Access Compliance Report

Public Rights-of-Way

(Curb Ramps)

Intersection ID: 45498	Main Street: COTTON_PRESS_RD	Cross Street: GRASSY_CROPS_RD	Location: E
ADA ID: 137F6D0EC738	Ramp Type: Perp	Initial Pass/Fail: Fail	Overall Compliance: No
Severity Score: 12.5			
Codes/Mitigation Info/Possible Solution		Field Measurements/Component Compliance

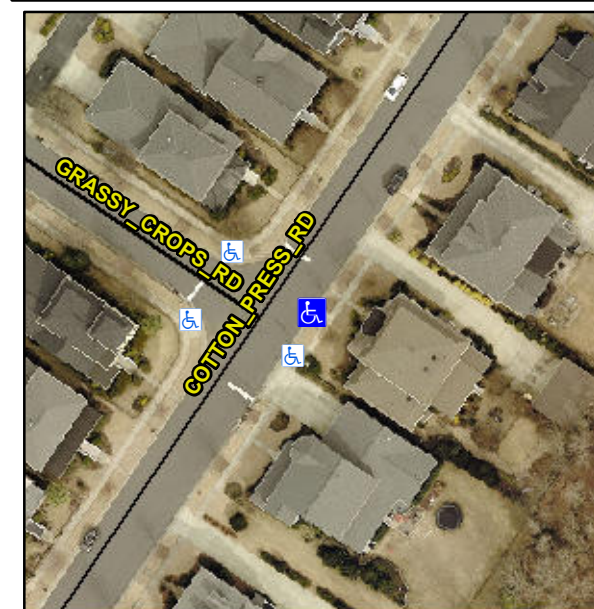
Not Found, R304.2.2

Compliance	Description	Data	Compliance	Description	Data
N/A	Ramp Length (in)	72.0	No	Ramp Slope (%)	9.7
Yes	Ramp Width (in)	48.0	Yes	Ramp XSlope (%)	0.7
N/A	Flare Type LT	N/A	N/A	Flare Type RT	N/A
N/A	Flare Slope LT (%)	N/A	N/A	Flare Slope RT (%)	N/A
N/A	Flare Traversable LT?	N/A	N/A	Flare Traversable RT?	N/A
N/A	Landing Length (in)	N/A	N/A	DWS Provided?	N/A
N/A	Landing Width (in)	N/A	N/A	DWS Contrast?	N/A
N/A	Landing Slope (%)	N/A	N/A	DWS Length (in)	N/A
N/A	Landing X Slope (%)	N/A	N/A	DWS Full Width?	N/A
N/A	Landing Curb? (Y/N)	N/A	N/A	DWS Offset (in)	N/A
N/A	Shared Landing?	N/A			
N/A	Gutter Ponding?	N/A	N/A	Gutter Slope (%)	N/A
N/A	Gutter Lip Ht (in)	N/A	N/A	Gutter X Slope (%)	N/A
N/A	Painted X Walk1?	No	N/A	Painted X Walk2?	N/A
	X Walk 1 Direction	To NW		X Walk 2 Direction	N/A
N/A	X Walk 1 Width (in)	N/A	N/A	X Walk 2 Width (in)	N/A
	X Walk 1 Slope (%)	1.0		X Walk 2 Slope (%)	N/A
	X Walk 1 X Slope (%)	0.9		X Walk 2 X Slope (%)	N/A

Remove & Replace Entire Ramp.
